## **STRUCTURE WIDTH**

**X = shy-line offset distance from the Table in Article 2.3.3.3**

### **BRIDGES – NO SIDEWALK**

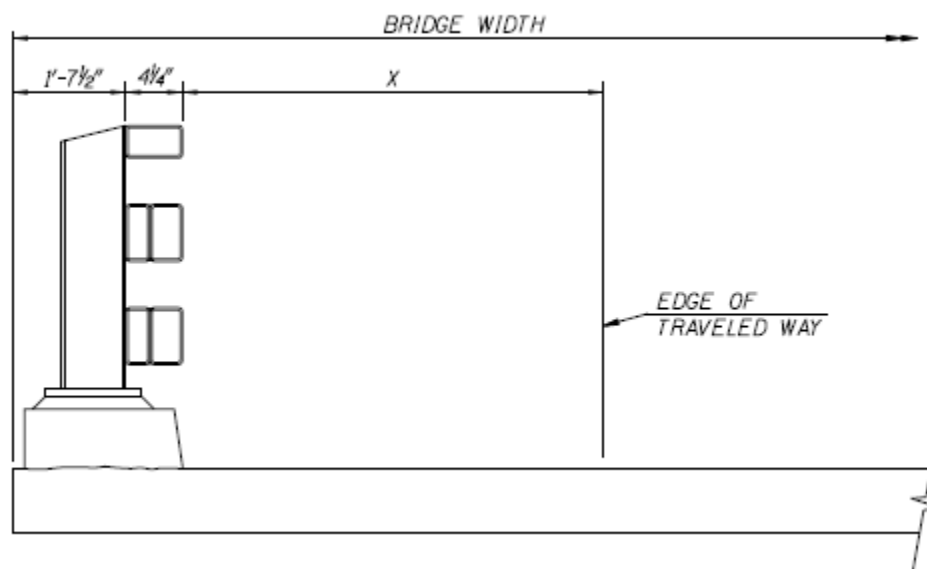
Deleted Jersey parapet detail for bridges with no sidewalk.

Revised two-tube curb mount rail to 3-tube curb mount rail detail for bridges with no sidewalk.

## **BRIDGES – RAISED SIDEWALK WITH SPEEDS 45mph AND LOWER**

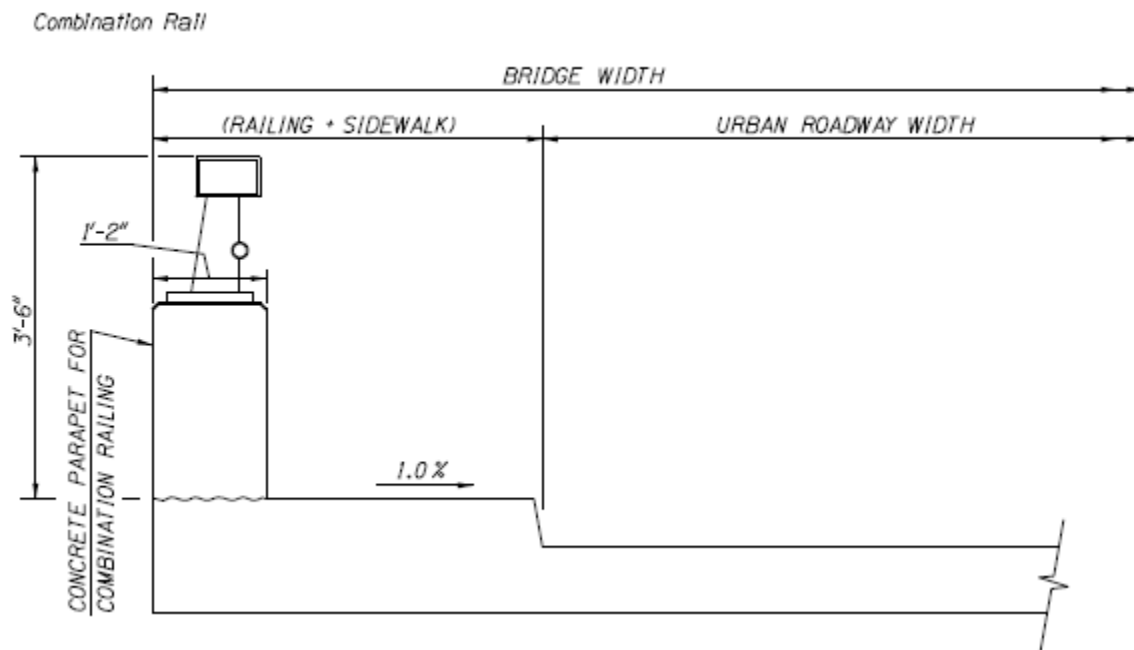
Revised combination rail detail to Texas combination rail details for bridges with raised sidewalk.

## **BRIDGES – AT-GRADE SIDEWALK FOR SPEEDS OVER 45mph**

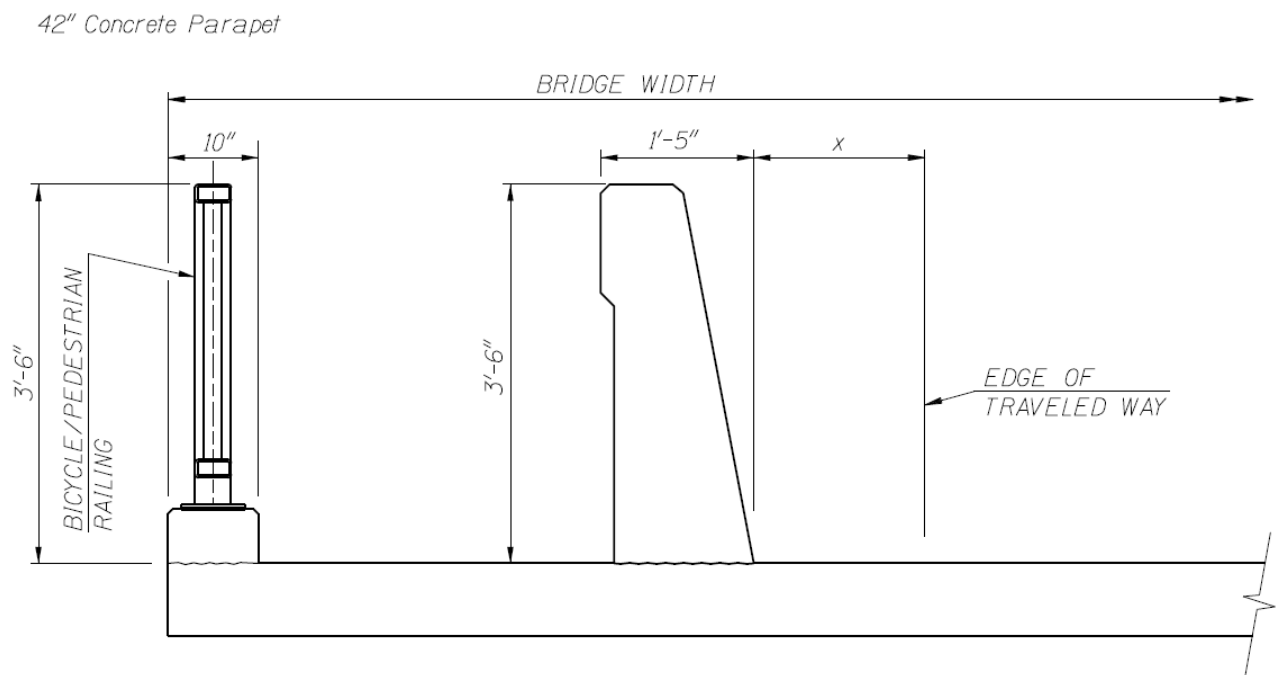
Revised Jersey parapet with metal rail to 42" single slope parapet details for bridges with at-grade sidewalk.

Metal Rail with posts attached to the culvert

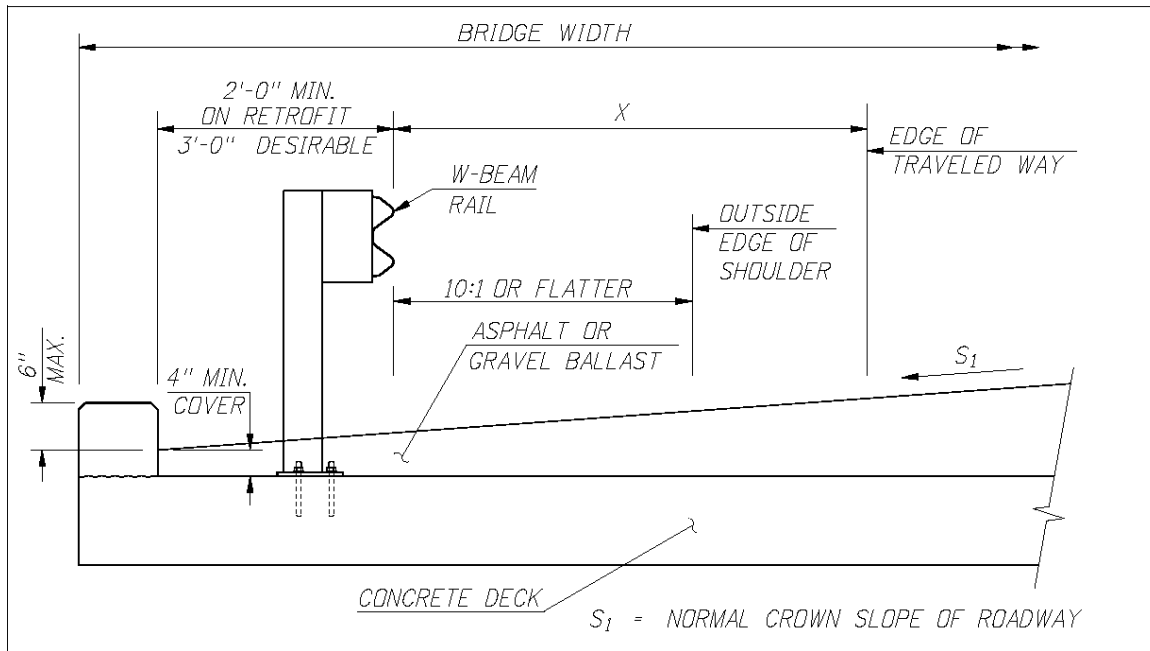
**Culverts – Clear Zone not Provided with posts attached to the culvert.**

Specified 6" maximum height of curb above fill.

Specified 10:1 or flatter roadway slope beyond edge of traveled way.

Metal Rail with no posts attached to the culvert

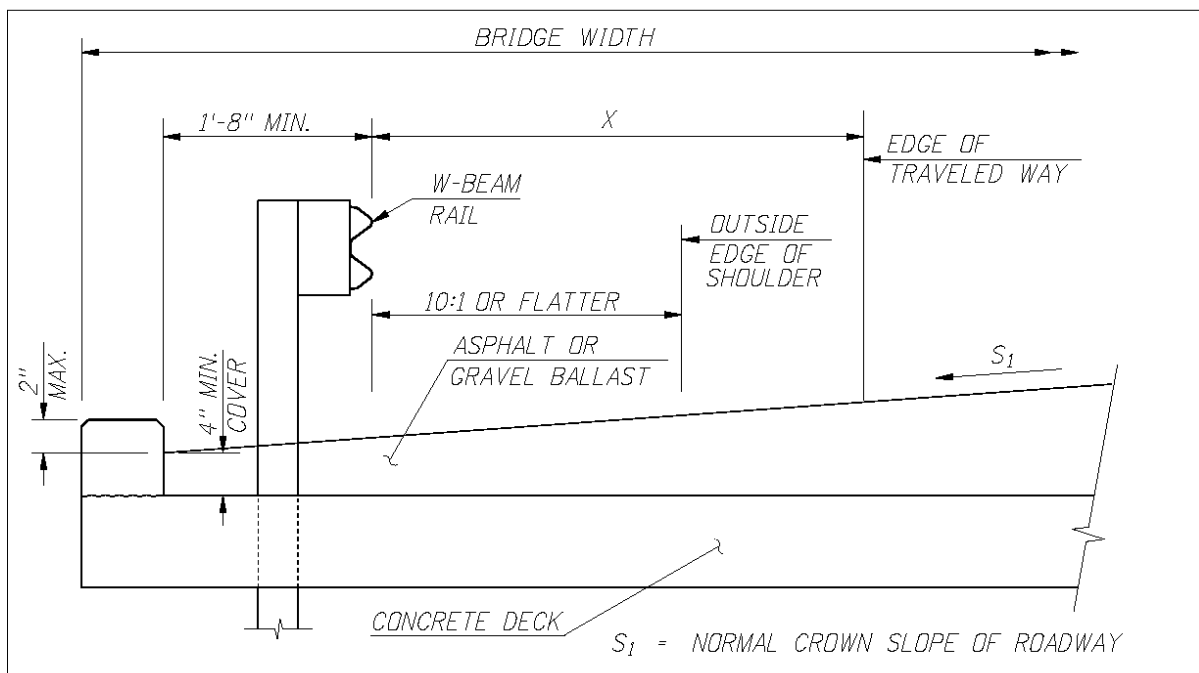
**Culverts – Clear Zone not Provided with no posts attached to the culvert.**

Specified 2" maximum height of curb above fill.

Specified 10:1 or flatter roadway slope beyond edge of traveled way.

42" Single Slope Concrete Parapet  
Staked Concrete Shoulder Barrier – Standard Drawing 612-18

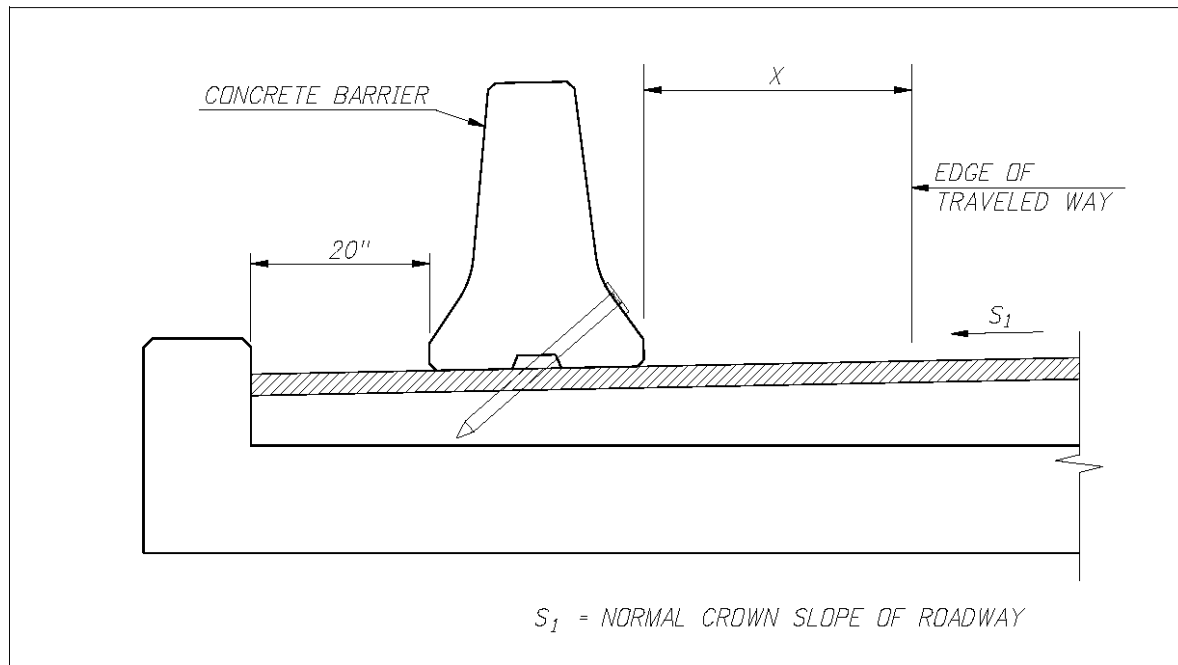
**Culverts – Clear Zone not Provided with concrete parapet.**

Changed from New Jersey parapet to 42" single slope parapet.

Changed shy distance from "X-4" to "X".

Specified 10:1 or flatter roadway slope beyond edge of traveled way.

**Culverts – Clear Zone not Provided with staked concrete parapet.**

Changed offset to face of curb from 3" to 20".

Changed shy distance from "X-4" to "X".

Revised reference to Standard Drawing from 612-5 to 612-18.

Specified 10:1 or flatter roadway slope beyond edge of traveled way.

### Single Slope Concrete Parapet with Moment Slab

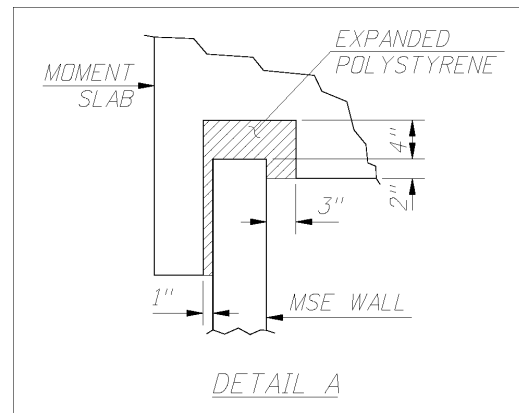
**MSE Walls with Moment Slab**

Changed from New Jersey parapet to 42" single slope parapet.

Added staked barrier in front of wall with a 20" offset.

### Concrete Barrier with No Moment Slab

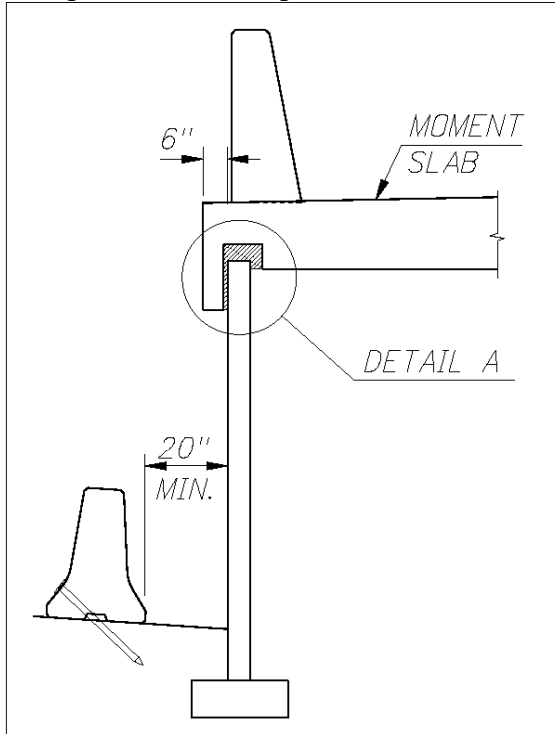
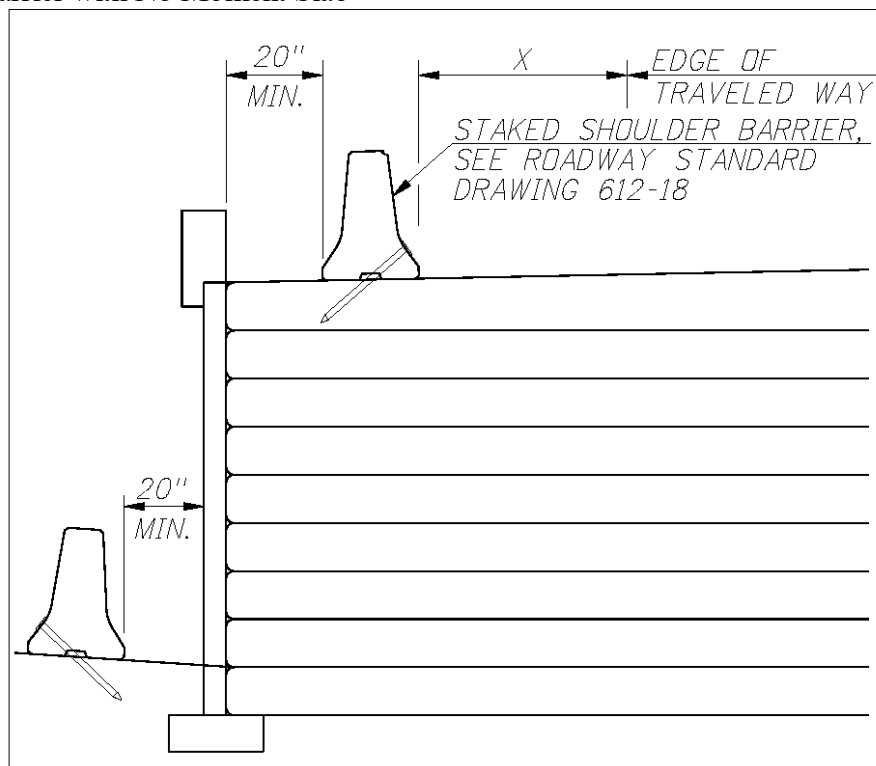
**MSE Walls with no Moment Slab**

Revised reference to Standard Drawing from 612-15 to 612-18.

Changed offset at top of wall from 2' to 20".

Specified 10:1 or flatter roadway slope beyond edge of traveled way.

Changed shy distance from "X-4" to "X".

Added staked barrier in front of wall with a 20" offset.

**MSE WALLS**  
Metal Rail

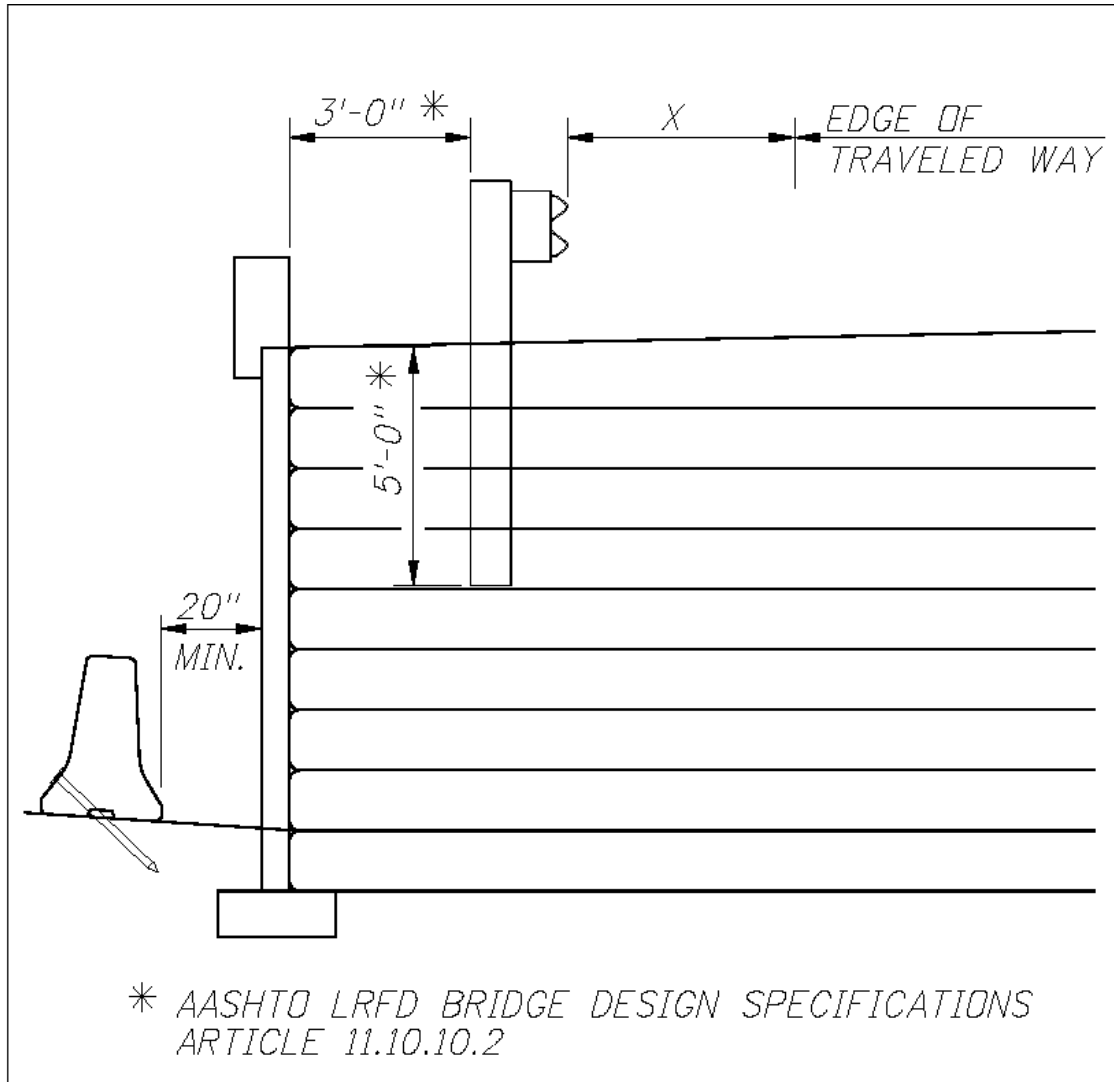
**MSE Walls with metal rail**

Specified 10:1 or flatter roadway slope beyond edge of traveled way.

Added staked barrier in front of wall with a 20" offset
